East Houston Street Ground Storage Tank Rehabilitation
Solicitation Number: CO-00651
Job No.: 22-0106

ADDENDUM 3
May 18, 2023

C9

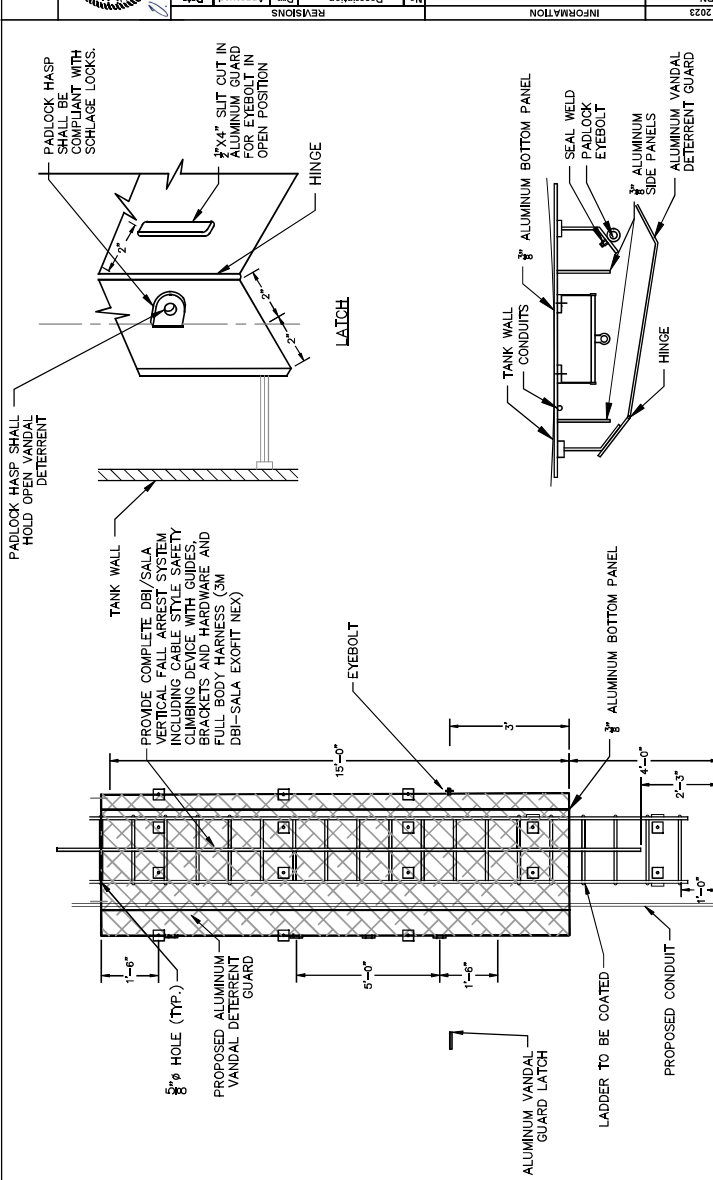
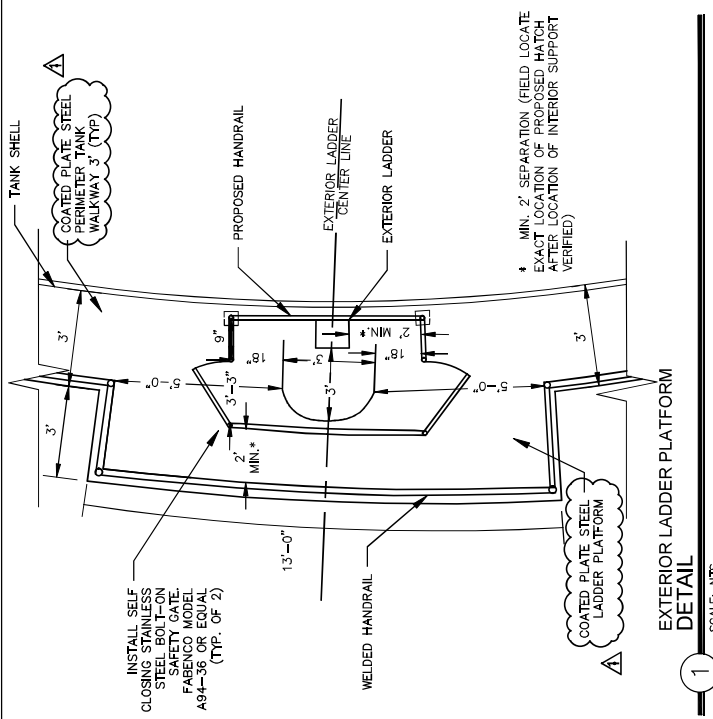
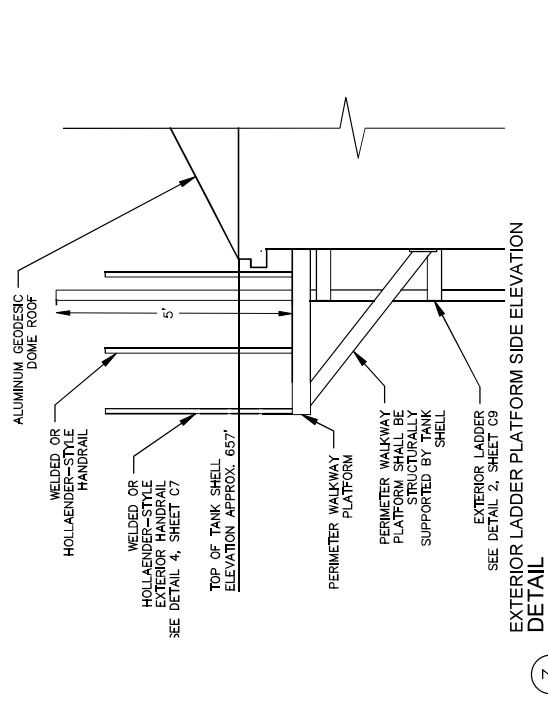
- 7. Question:** Please confirm if the new walkway at the roof will be bare carbon steel, galvanized, or other
Response: The perimeter walkway shall be coated plate steel. This will be clarified in the plans. Refer to the "Changes to the Plans" section of this Addendum.

1. Sheet C9 – General Details (Sheet 4 of 6)

Remove and replace in its entirety with the attached sheet C9 – General Details (Sheet 4 of 6)

2. Sheet C11 – General Details (Sheet 6 of 6)

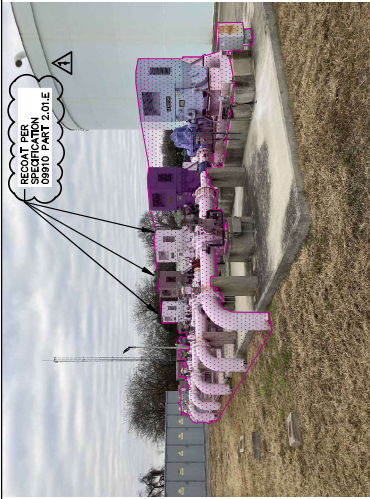
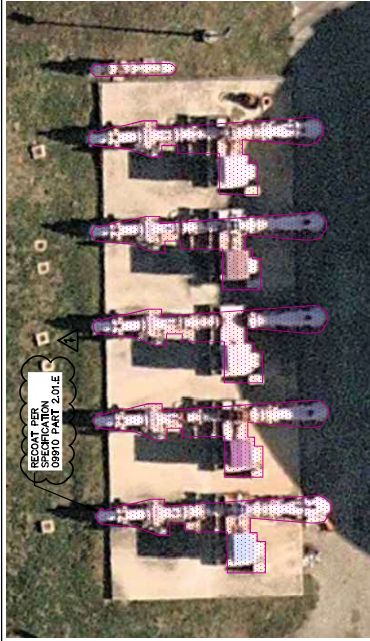
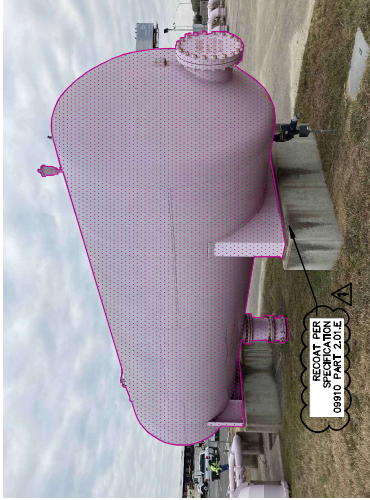
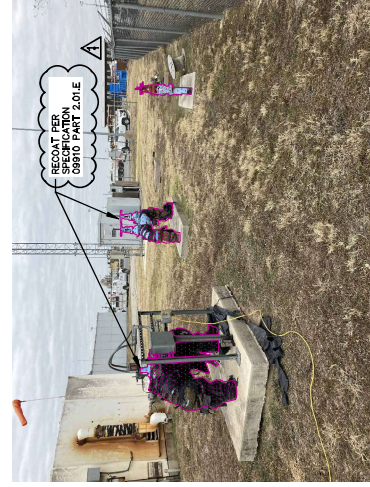
- 8. Question:** The legend on drawing G4 has an item listing equipment to be overcoated in a purple shaded areas. However, drawing C11 shows these same areas and states to recoat per specification 099100. Specification 099100 page 11, paragraph C describes the paint system for "Exterior Equipment, Valves and Piping and lists the surface preparation as commercial blast cleaning per SSPC-SP6 which is a complete removal/recoat vs. an overcoat. Please clarify if equipment, piping and valves highlighted on drawing C11 get a paint overcoat or full removal/recoat.

Response: The equipment, piping, and valves highlighted on drawing C11 shall be overcoated, not blasted and recoated. The applicable section for this work in Technical Specification 09910 is Part 2.01.E., whereas Part 2.01.C applies to equipment, valves, and piping that are connected to the GST. Refer to the "Changes to the Plans" sections of this Addendum.

Remove and replace in its entirety with the attached sheet C11 – General Details (Sheet 6 of 6)
